FW: DEP File #050-1386 Notice of Intent 3-33rd Street Newbury MA

Please be advised that I have reviewed the grading plan and details shown on "Site Plan Sea-Chanty/Cataldo Proposed Driveway prepared by Oak Consulting Group dated May 13, 2022" and have the following comments:

GRADING ANALYSIS
106 NORTHERN BOULEVARD
@ 33RD STREET
NEWBURY, MASSACHUSETTS
BASED ON SITE PLAN DATED MAY 13, 2022
BY OAK CONSULTING
SCALE: 1"=1'-0" DATE: OCTOBER 10, 2023
MERRIMACK ENGINEERING SERVICES
66 PARK STREET
ANDOVER, MASSACHUSETTS 01810
TEL: (978) 475-3555 FAX: (978) 475-1448
EMAIL: MERRENG@AOL.COM

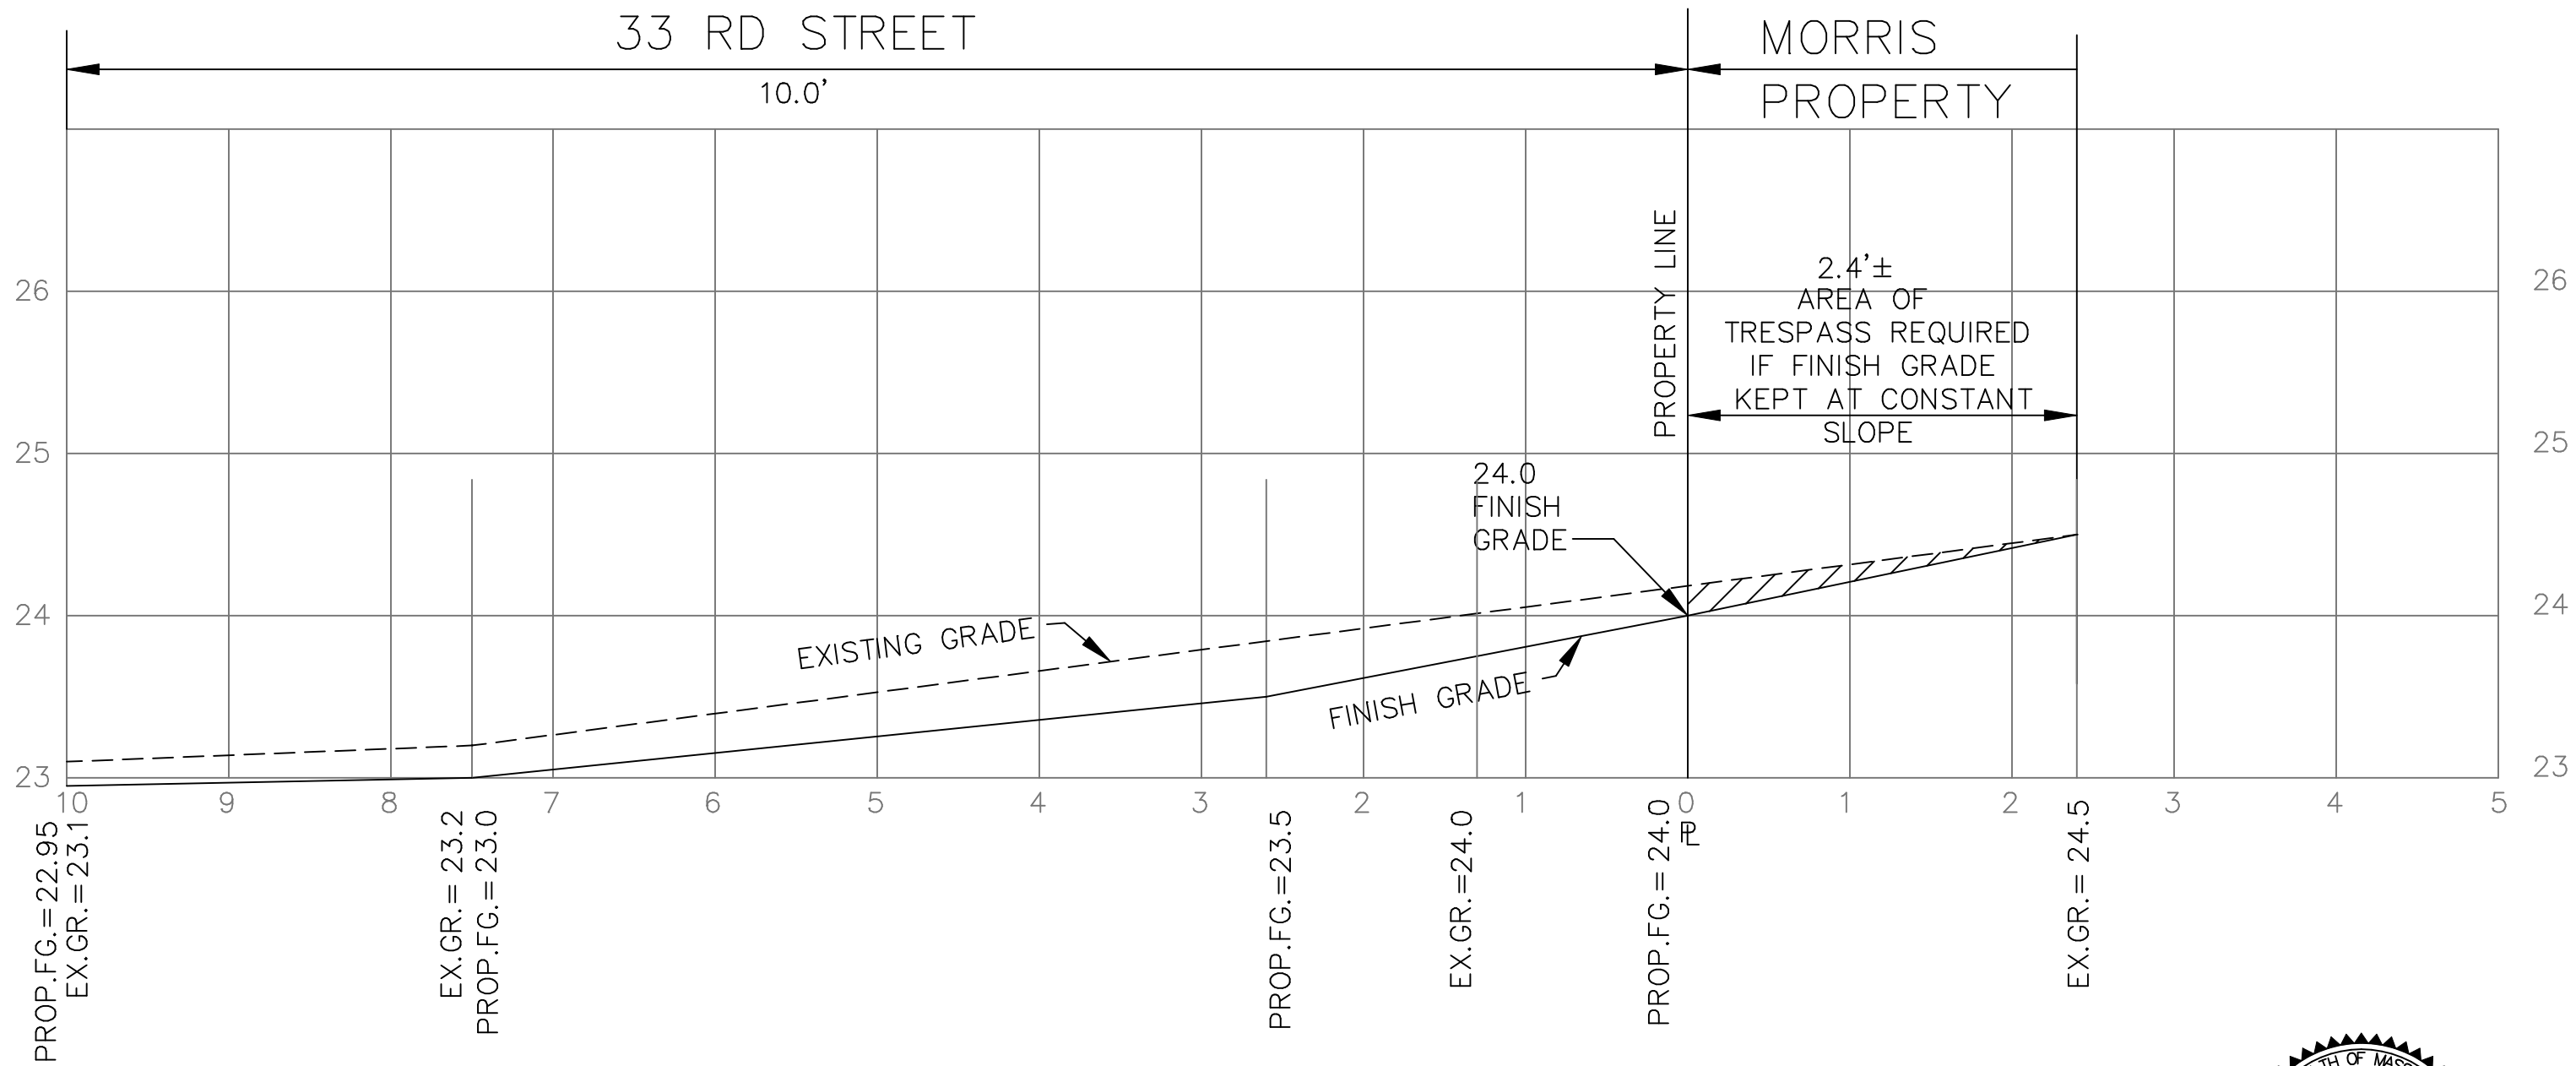
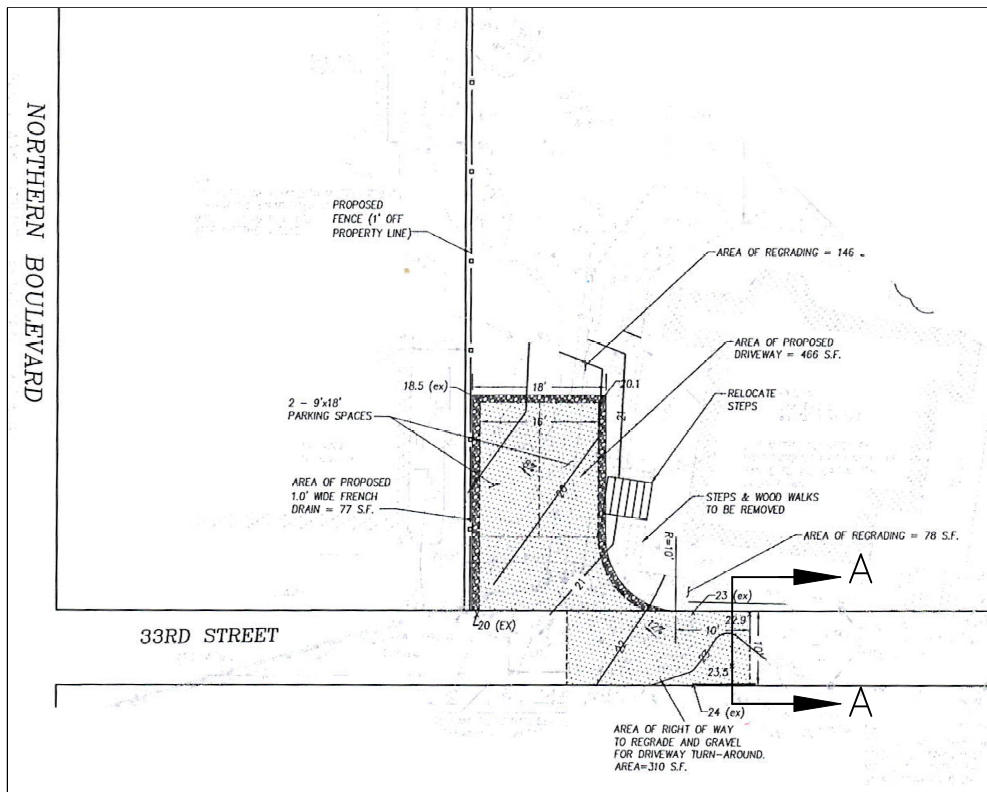
1. To achieve the required turning radius and to make a turn sufficient to drive out of 33rd Street to Northern Blvd, an additional 7' or 70 sq ft of disturbance to the right of way (toward the Ocean) is required, so the area of regrading is misstated on the plan and not sufficient (AASHTO standard passenger vehicle is 7' x 19' with an 11' wheel base)

2. To achieve the grading of the right of way shown on the plan (attention is called to the 24 finish grade contour along the Morris Property line and the existing 24.5 spot grade shown on the plan on the Morris property and the location of the 23.5 finish grade shown in the 33rd Street right of way), it would be necessary to enter the Morris property to start the grading so the 24 finish grade is built where shown on the plan. In other words, the finish grading shown on the plan in the right of way could not be achieved, in any scenario and by any method, without entering onto the Morris land for regrading of the Morris land.

3. The driveway design is proposed to be porous pavement consisting of 2" of crushed clam shell, pea stone or other natural aggregate bordered by a "French Drain" otherwise known as an infiltration trench. The driveway is also proposed to be sloped at a finish grade of 10% to 12% as shown on the plan. According to the DEP Stormwater Handbook, Volume 2 (pg 119 of 133) the maximum slope on which porous pavement is permitted is 5%. Thus the design of the finish pavement of the parking area is not suited to the DEP BMP that is proposed. Further, the design of the porous surface does not meet the design requirements of the DEP BMP. The infiltration trenches should not be used on slopes exceeding 5% as the slope of the installation does not allow water to be stored in the voids, and will cause the water that is within it to flow in the trench and actually exit it, in the case of this design, at 15' intervals-causing directed erosion within the right of way and possibly onto the adjacent property. Therefore, the design does not comply with the DEP

Stormwater Handbook for both the porous pavement and infiltration trenches.
